CONTRACT CHANGE ORDER NO. ____
SHEET ____ OF ____

MARK	DATE	DESCRIPTIONS	BY	CH'D	CCO#
3	08/10/12	TOWER CAULKING	NV	MN	256
2	07/07/08	CAULKING	MN	NV	66
1	06/23/06	SPLICE PLATES PER ISM	MN	NV	21

SAN FRANCISCO OAKLAND BAY BRIDGE
EAST SPAN SEISMIC SAFETY PROJECT
SELF-ANCHORED SUSPENSION BRIDGE
(SUPERSTRUCTURE & TOWER)

TOWER SPLICE DETAILS NO.13

DETAIL G
1:5

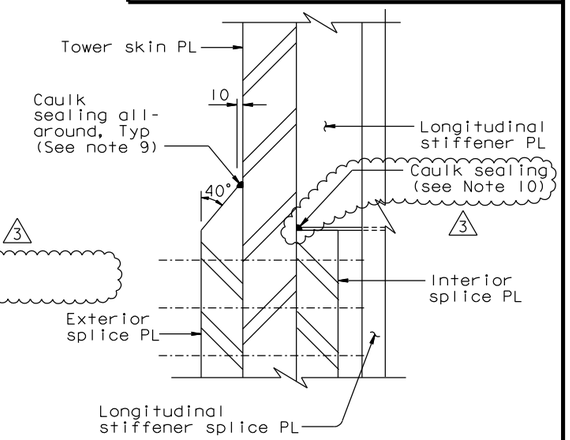
3 10. Caulk sealing shall be applied along the exposed upper horizontal edge and exposed vertical edges of all interior splice plates, interior corner splice plates, and shim plates. For upper horizontal edges, caulk sealing shall be continuous through the longitudinal stiffener plates by filling the gap between longitudinal stiffener plates and interior splice plates.
